Purcell-enhanced spin-phonon coupling with a single color-center

Corresponding Author: Dr Graham Joe

This file contains all reviewer reports in order by version, followed by all author rebuttals in order by version.

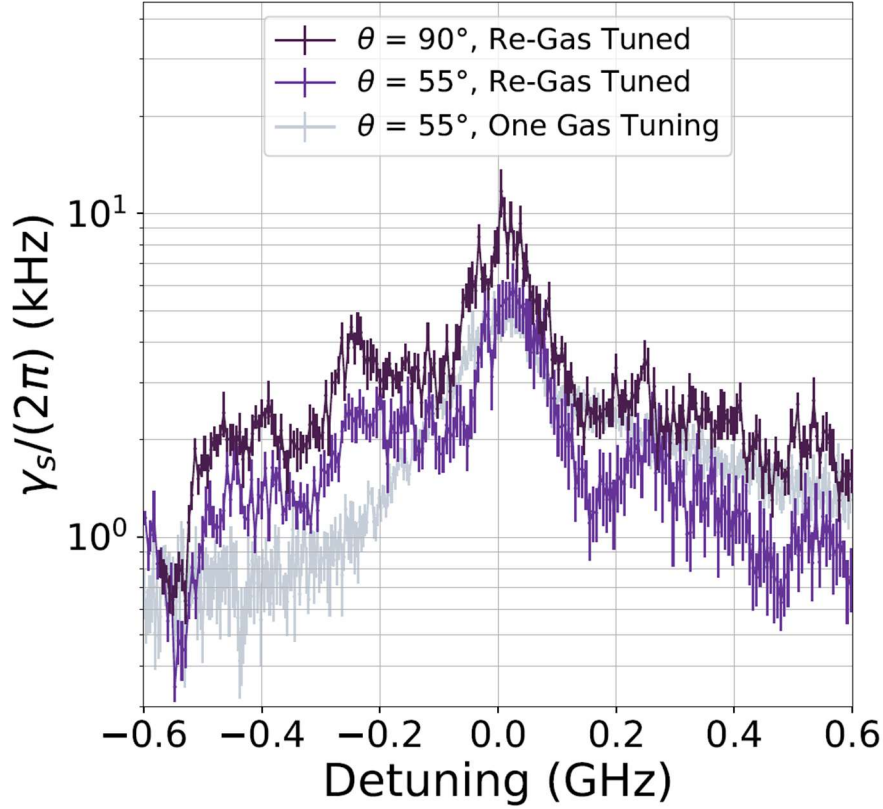
I thank the authors for their detailed response to my questions and comments. Most of these have been adequately addressed. The remaining one is with regard to the B_{normal} dependence of the acoustic Purcell effect for the 12 GHz mode.

The main reason I have asked for this additional data is that Fig. 19 shows good agreements between the experiment and simulation for the 12 GHz mode but does not show the strong Purcell effect observed for the 21 GHz mode. On the other hand, the B_{normal} dependence (see Fig. 13), which I consider as the most conclusive data for the acoustic Purcell effect, is demonstrated for the 21 GHz mode, but not for the 12 GHz mode.

- 1) Revise/expand Fig. 19 to reproduce the strong Purcell effect observed for the 21 GHz mode in the simulation.
- 2) Include experimental data on the characterization of the 21 GHz mechanical mode as well as the 12 GHz mechanical mode in the supplement.

Regarding the $B_{\perp}$ dependence of the 12 GHz mode, we agree that an equivalent of Fig. 13 for the 12 GHz mode would have been a more ideal measurement due to the thorough characterization of that mode. As the referee notes, the full angular dependence measurement for the 12 GHz mode is technically challenging, particularly near the SiV high symmetry axis where the optical transitions used for spin initialization cross. These constraints ultimately led us to focus on the cleaner and more complete dataset for the 21 GHz mode presented in Fig. 13.

However, we do have measurements of the 12 GHz mode taken under gas-tuning-only conditions for both a 55° and 90° aligned field. This data was originally omitted from the manuscript and SI to avoid presenting extraneous experimental details that could distract from the main narrative. The measurements were performed by tuning the optical mode into resonance with the SiV C-Line using gas deposition, then boiling off the gas with a high power laser and the re-gas tuning. This repeated procedure further degraded the mechanical resonance - likely due to residual gas outside the cavity center - resulting in a mildly distorted resonance shape (see Fig. 14 below and now in SI Sec. 5.9). The mode quality was later restored after cleaning the chip and depositing ALD Alumina.

Despite these complications, the data clearly shows the theoretically expected angular dependence of the 12 GHz mode, more perpendicular magnetic field leads to faster spin-decay rates. This is consistent with the trend established in Fig. 13 for the 21 GHz mode, and with all other measurements performed throughout the course of this experiment. We have included this new figure and its caption in SI Sec. 5.9 along with the following text to reflect this discussion:

“In Fig. 14 we show measurements of the 12 GHz mode taken under gas-tuning-only conditions for both a 55° and a 90° aligned field. The gray curve is the data presented in Fig. 3b after a single gas tuning for a 55° aligned magnetic field. The other two measurements were performed by then boiling off the gas with a high power laser and re-gas tuning. This repeated procedure further degraded the mechanical resonance - likely due to residual gas outside the cavity center - resulting in a mildly distorted resonance shape. The mode quality was later restored after cleaning the chip and depositing ALD Alumina. The data clearly shows the theoretically expected angular dependence of the 12 GHz mode; a more perpendicular magnetic field leads to faster spin-decay rates. A full angular dependence for the comparatively low frequency 12 GHz mode is experimentally challenging due to a crossing of the optical transitions used for spin
